Interactive comment on “Hydrogeomorphological analysis and modelling for a comprehensive understanding of flash-flood damaging processes: The 9th October 2018 event in North-eastern Mallorca” by Joan Estrany et al.

RC2 - Anonymous Referee #2 Received and published: 3 February 2020 SUMMARY: This manuscript analyses a flash flood event in a small catchment in the North-Eastern part of the Spanish Island of Mallorca, that left 13 people dead and caused severe damages to local properties. The analysis looks into four main aspects of the event, namely the meteorological conditions, the hydrological and hydraulic response, the damage assessment and a geomorphological analysis with the aim to improve the understanding of the drivers of this respective event. The authors conducted field measurements

Fig. 2. Figure S2. Scatterplot of recorded rainfall in meteorological stations and estimated rainfall by using different grid radar.

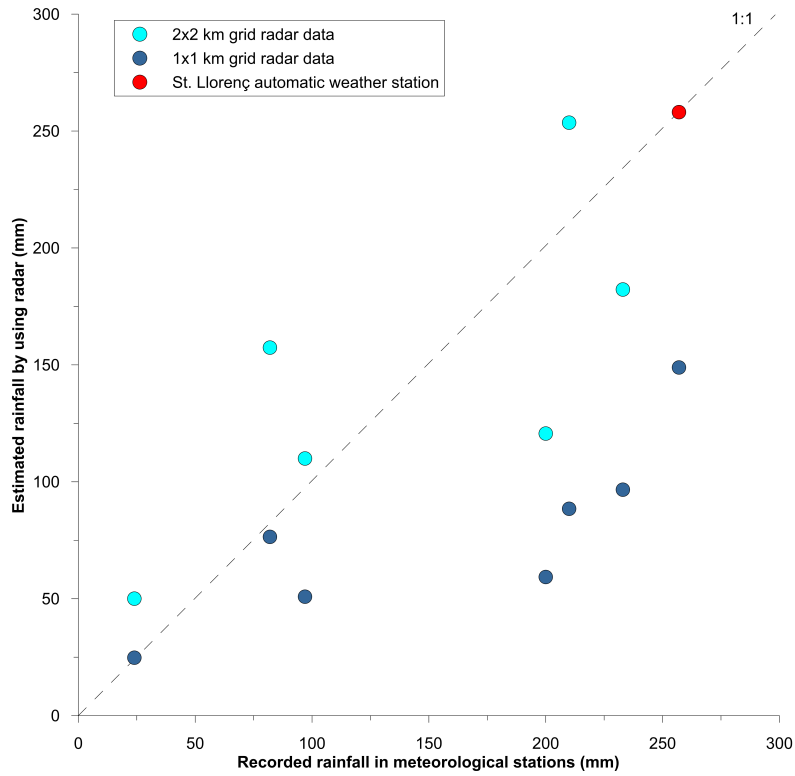
Rainfall This paper focusses on the hydrological response as a main driver of the flash floods and the authors argue in the introduction that "the uncertainty in hydrological modelling can be large and hydrological models often need to be calibrated [. . .]. Therefore, the predictability of such events remain low also adding that predictability is lowered by a high non-linearity in the hydrological response related to threshold effects". This implies that the uncertainty in the hydrological models are a key barrier in the predictability of flash floods. However, most other studies on flash floods and flash flood early warning systems find the spatio-temporal uncertainties in the rainfall prediction to be the largest obstacle in accurately forecasting and modelling flash floods (see for example Alfieri et al. 2017). This issue is also addressed in the description of the rainfall data, but the authors do not report to what extend the results of the subsequent hydrological and hydraulic models are sensitive to the uncertainties of the rainfall input. Therefore, I would recommend adding a short sensitivity analysis in regard to the rainfall input to the discussion section. It would also be interesting to see to what extend the results vary between the radar and gauge data.

We thank the reviewer on this very pertinent and interesting comment. We fully agree that the spatio-temporal uncertainty in the rainfall data is the main source of uncertainty in flash floods, an issue also commented by the Anonymous Referee #1. We recognize that the text in our manuscript was misleading and we have accordingly modified the Introduction section (see Lines 76-78 of the revised MS): “The main source of uncertainty is related to the spatio-temporal scales of rainfall pattern. The forecasting of intense thunderstorms by numerical weather prediction systems to provide accurate rainfall information is particularly challenging (Alfieri et al., 2015; Collier, 2007)”. Otherwise, the scientific issue aroused from this comment is very challenging. We believe that analysing the uncertainty sources of the hydrological model in this particular paper is out of scope, would mislead the reader also considering this topic would deserve a paper on its own. However, we have specifically minimized this uncertainty source by using a spatially interpolated rainfall from gauging stations in order to understand –from a modelling point of view– the processes leading to this event. It is clear that the estimated radar rainfall data used in our piece of work have provided a better spatial interpolation of the rainfall event than using only the radar data (see Fig. S1 and the Lines 265-270 in the subsection 2.3. Rainfall data of the revised MS). Moreover, the radar data was adjusted with data from San Llorenç des Cardassar station as described in this same supplementary figure (Fig. SF1) so that indirectly the rainfall data is already used in the model. Definitely, it would be interesting to further analyse the results of the uncalibrated radar data in these kind of extreme rain storms but it should be a future scientific work.
